SUBJECT: Consider a Request for Approval to Demolish an Existing Single-Family

SUBJECT: 14331 Capri Drive/S-24-043, Z-23-005

RE: 14331 Capri Drive

RIGHT SIDE ELEVATION: Currently Proposed

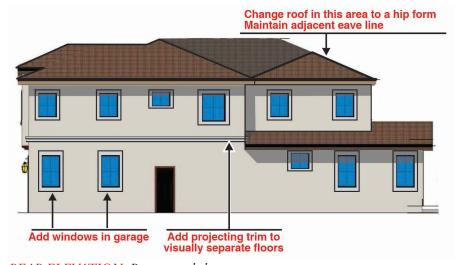
- This recommendation was incorporated.
- 6. Add trim at the bottom of the projecting bay on the right side elevation and enlarge the size of the supporting corbels. Exposed roof rafter tails were shown in a very limited area: eliminate them or carry them consistently around all eaves (RDG 3.3.3, 3.6.2).

RIGHT SIDE ELEVATION: Recommendation

Letter of Justification (Shed Roof)

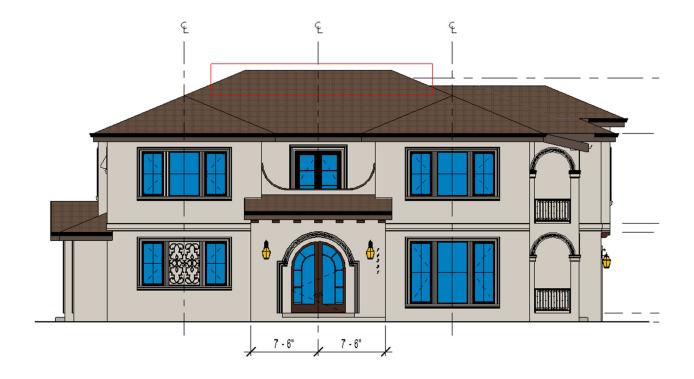
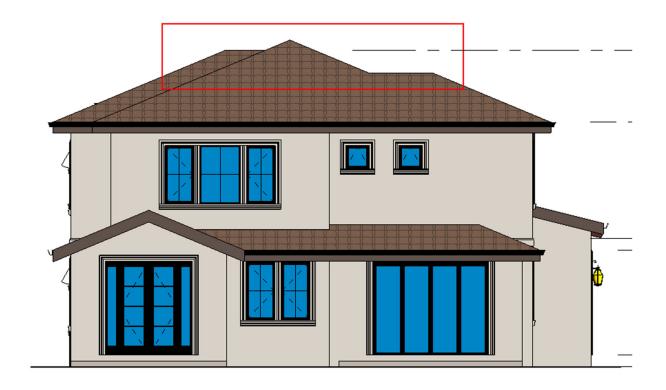
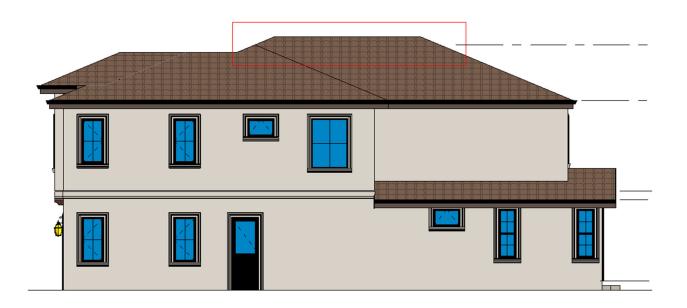
- 8. Change the extended roof overhang at the Master Bedroom on the rear elevation to a hip roof (not related to a referenced RDG).
 - This cannot be done as it will result in a cricket in between the two hips. In addition, the roof was carefully designed in a way to reduce the amount of 'pointy' peaks while keeping the simplicity of the ridge lines (Exhibit 7).

Design without shed roof @ Master bedroom, instead with hip and valley within 16 inches from the exterior wall
